Project 1 Albany Terrace, Park Square East, London, NW1 4DS

Title Proposed Ground Floor

Number 296_34_10 Rev B

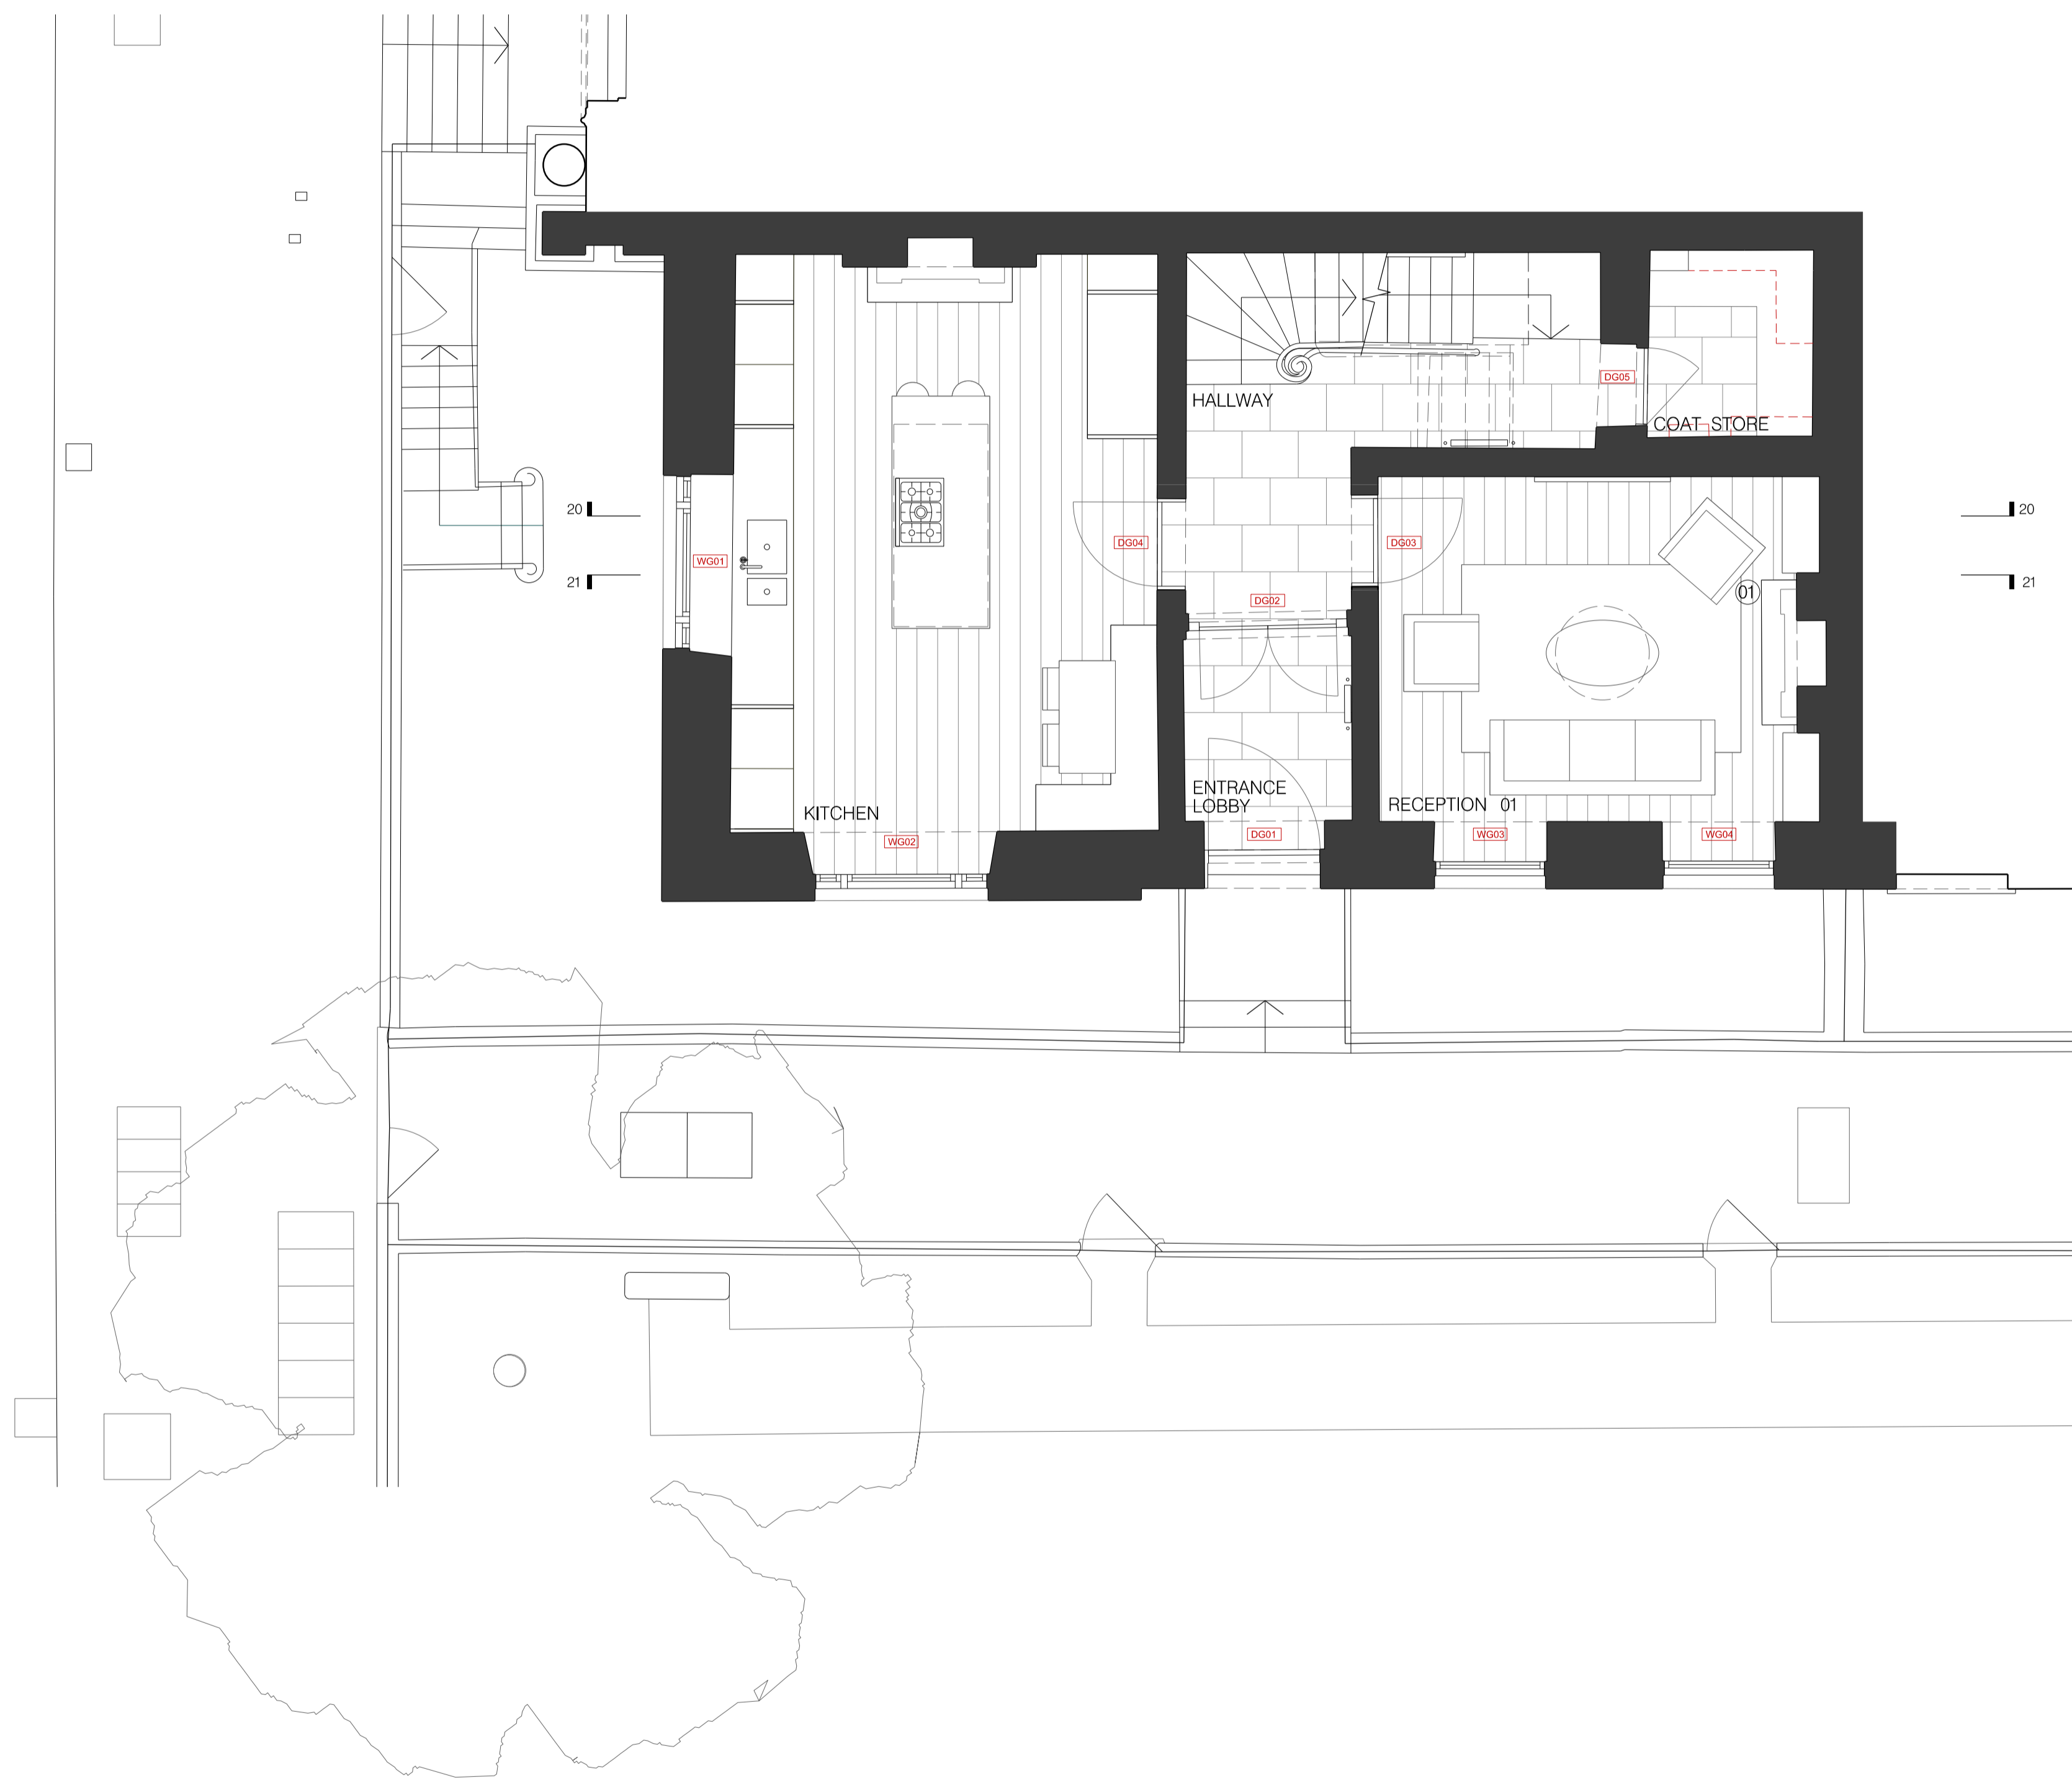
- 01 NEW PROPOSED FIREPLACE SURROUND, HEARTH, SLIPS, FIREPLACE INTERIOR, NOTING EXISTING FIREPLACE IS NON-ORIGINAL. SEE FIREPLACE PROPOSAL BELOW

ORIGINAL CLARENCE WITH BULLSEYE CORNER BLOCKS; BLACK ARCHED INSET AND WHITE MARBLE, TO MATCH ORIGINAL FIREPLACE

HEIGHT 119.4cm
 WIDTH 164cm
 INT HEIGHT 101.6x101.6cm

Revision	Date	Description
A	26.03.24	Chimney piece revised to Conservation Officer comments
B	12.04.24	Revised to Conservation Officer comments
